PLANNING COMMISSION STAFF REPORT

Preliminary Minor Subdivision 490-08-18
for Bilanzich Subdivision
located at 2347 S Lakeline Drive
June 25, 2008

SUBJECT: 490-08-18 – Bilanzich Subdivision located at 2347 Lakeline.

Attachment C
Preliminary Plat

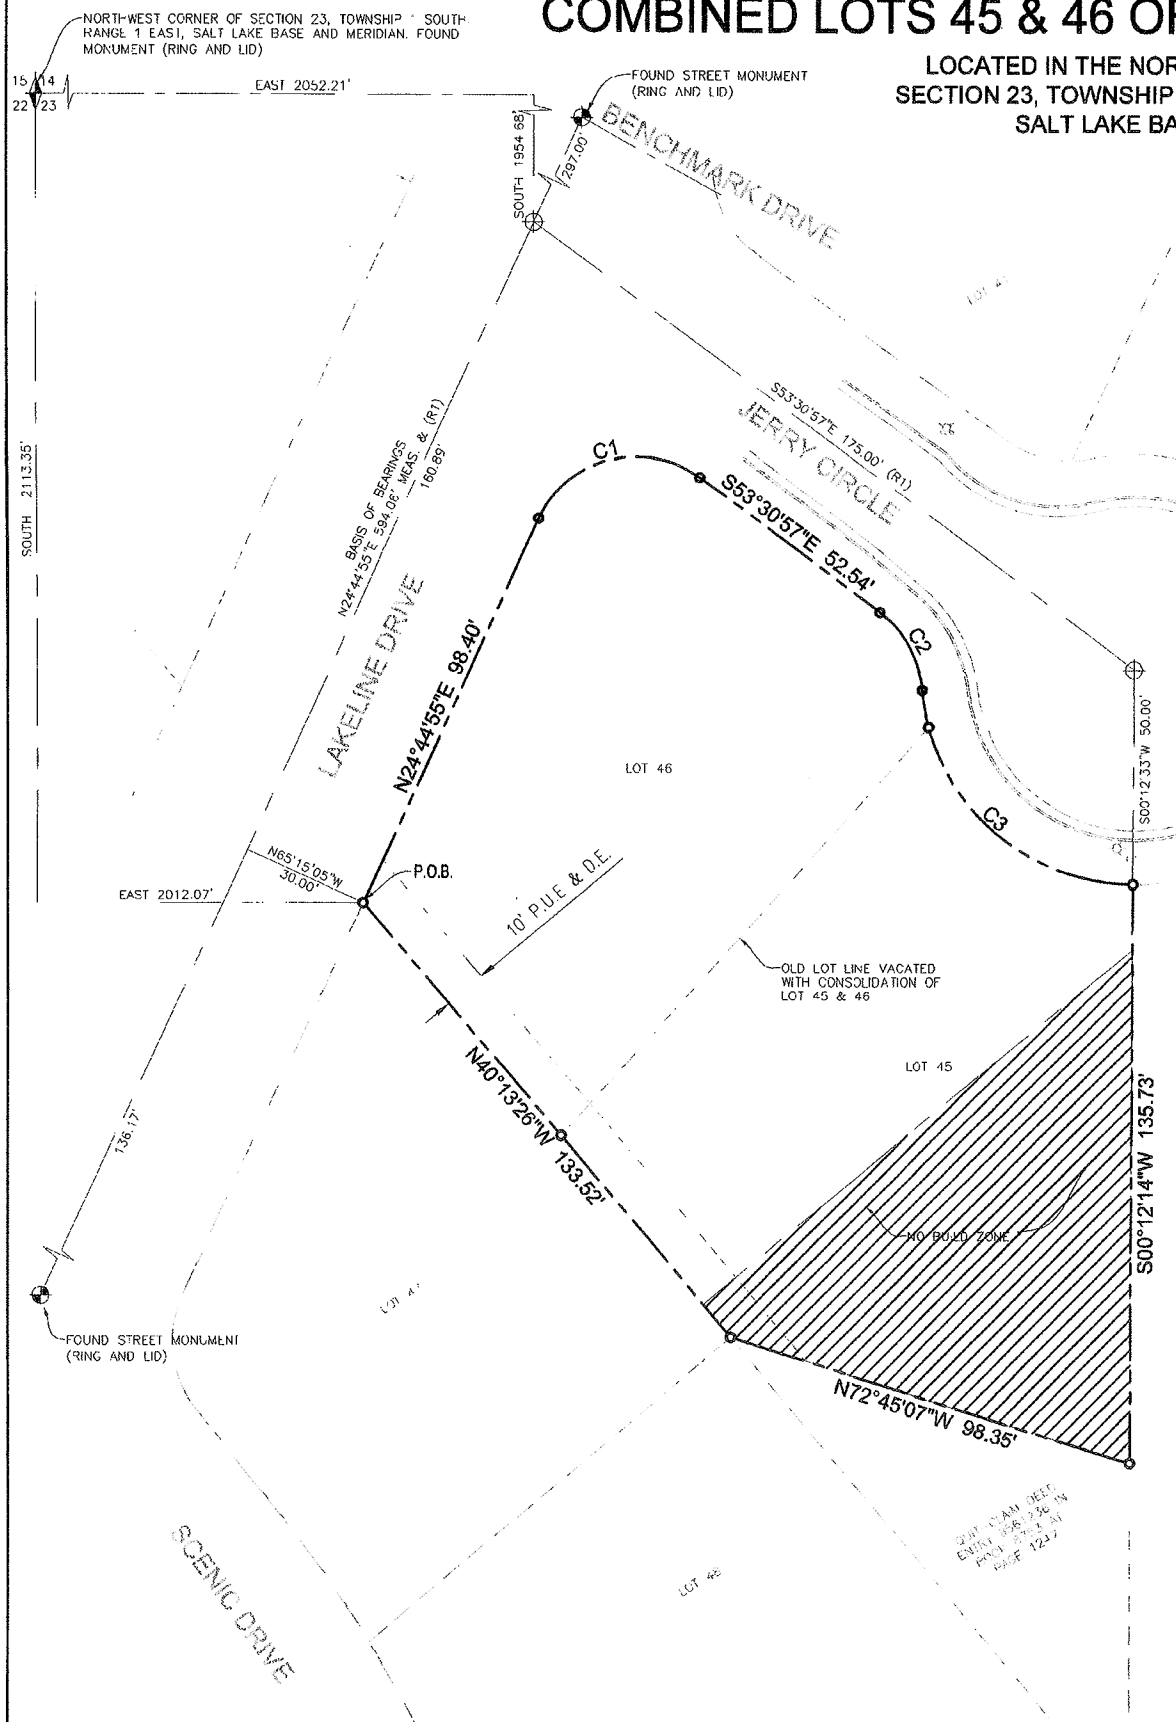
- 1 This submission consists of a dwelling on two lots being combined into one lot. It is located at 2347 Lakeline. It is a corner lot and both frontages are improved with curb, gutter, and asphalt paving. The street has sufficient dedication, and the only requirement is that there are two sections of curb and gutter on the Jerry Circle frontage where a tree has raised the curb so that proper drainage does not occur, and the curb and gutter needs to be replaced as per APWA Std. Dwgs No. 205A and 252. We would recommend that the tree be removed to eliminate this problem from occurring again. This replacement shall be done by a licensed, bonded and insured contractor after obtaining a Public Way Permit to do so.
2. The plat is being reviewed and any concerns will be made known to the applicant's surveyor via a 'red-lined' copy for correction and re-submission.

Verify the street name noted as Jerry Circle, our files show Skyridge Circle (2340 So)

- The proposed lot area of the lot consolidation is .78 acres or 33,976 square feet. The maximum allowed lot size in the FR3/12,000 district is 18,000 square feet. There are exceptions to allow for greater lot size based on some standards of compatibility. The other lots within the cul-de-sac are not greater than or equal in size than the proposed lot consolidation. Please review these standards 21A.24 040 J (exceptions)

- 1 We will need a title report ran. The title report should be dated within two weeks of being submitted to the City Attorney's office.
- 2 Regarding the Owner's Dedication, it needs to be specific as to who is signing the dedication. It should read

I am concerned about making certain that the boundary between my lot 44 and his lot 45 is properly identified in the petition

Was this portion transferred in its entirety to Lot 45 and is it described in surveyor's terms in petition 490-08-18?
